**AGENDA  
CITY OF CEDAR FALLS, IOWA  
PLANNING AND ZONING COMMISSION MEETING  
WEDNESDAY, JANUARY 09, 2019  
5:30 PM AT CITY HALL**

**TO:** Planning & Zoning Commission  
**FROM:** David Sturch, Planner III  
**DATE:** January 3, 2019  
**SUBJECT:** College Hill Neighborhood Site Plan Review – 2119 College Street

**REQUEST:** Request to approve a College Hill Neighborhood District Site Plan Review for a new multi-use building at 2119 College Street.

Building Height Comparisons

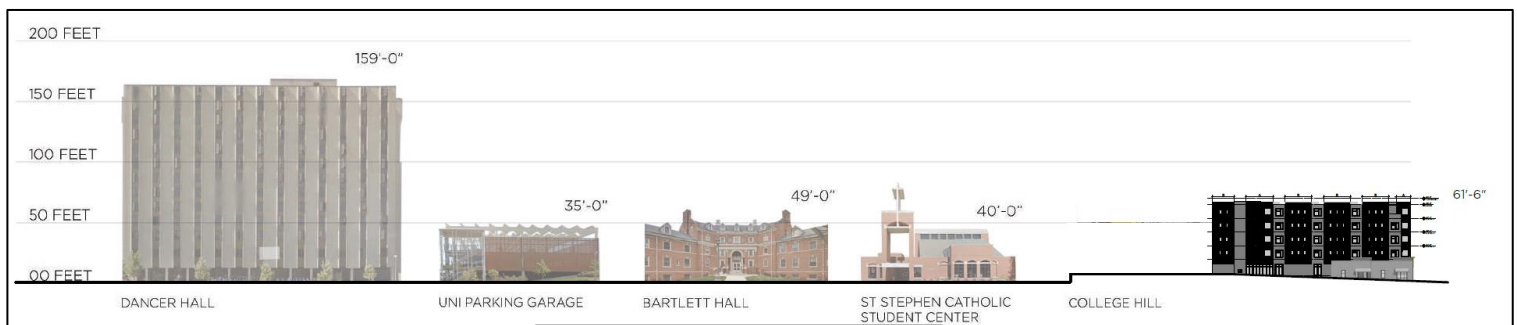
Most of the buildings in this immediate area are either one-story or two-story in height. The proposed building will be 5 stories in height, which would replace two existing two-story structures that are currently on the property. The property is zoned C-3 Commercial District, which has a building height limitation of 165 feet or three times the width of the road that the building faces. In this case College Street is 40 feet in width, meaning that the maximum building height allowed would be 120 feet (40 feet x 3). As this structure would be 61 feet 6 inches in height, it would meet the height requirement of the Zoning Ordinance. This property is also located within the College Hill Neighborhood Overlay

The applicant has provided a diagram which shows several other buildings within a 2-3 block area that are taller than the proposed building (see attached diagram for building locations). In the diagram, it shows the proposed building with a height of approximately 62 feet. Other buildings in the area and their heights include the St. Stephen Catholic Student Center on W 23<sup>rd</sup> Street at 40 feet in height, Bartlett Hall on the UNI campus on W 23<sup>rd</sup> Street at 49 feet in height, the UNI parking garage on W 23<sup>rd</sup> Street at 35 feet in height, and Dancer Hall on Campus Street on the UNI campus at 159 feet in height. Also, the applicant has provided a side elevation diagram which shows the street section of buildings located on College Street and their height comparison to the proposed building. Based on the diagrams presented below, staff feels that the building scale and height will not be out of character for the area, as there are other structures within the neighborhood that are comparable in scale and height to the proposed building.

**East Elevation**

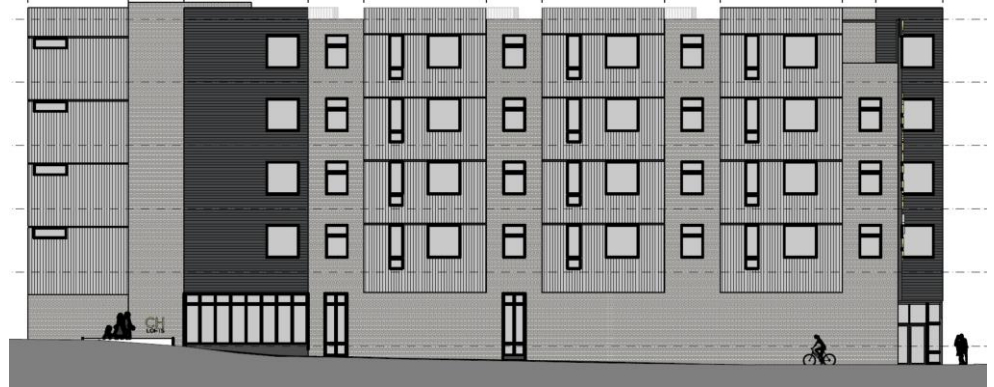
Most of the buildings in this immediate neighborhood are constructed with brick materials. The proposed building will have a more modern look, as it will be constructed with a mix of metal paneling (with a contrasting color and design), brick and glass openings. The colors include charcoal/black for the entry masses at the front and rear of the building with off-white as the metal panel along the larger north and south portions. The brick is planned to be a neutral tan/gray with brick detailing similar to the image shown at key locations. Each of the four sides of the building will have a slightly different design in relation to the amount and type of materials used. Please see the table below which breaks down the use of materials by building side.

The building has a width of 45 feet as viewed from College Street, but is broken into three modules, distinguished by changes in building material, wall plane, colors, and textures. The sides and rear of the building are also broken into modules with similar changes in material, color, and changes in the wall plane that helps to break up the mass of the building from all vantage points.
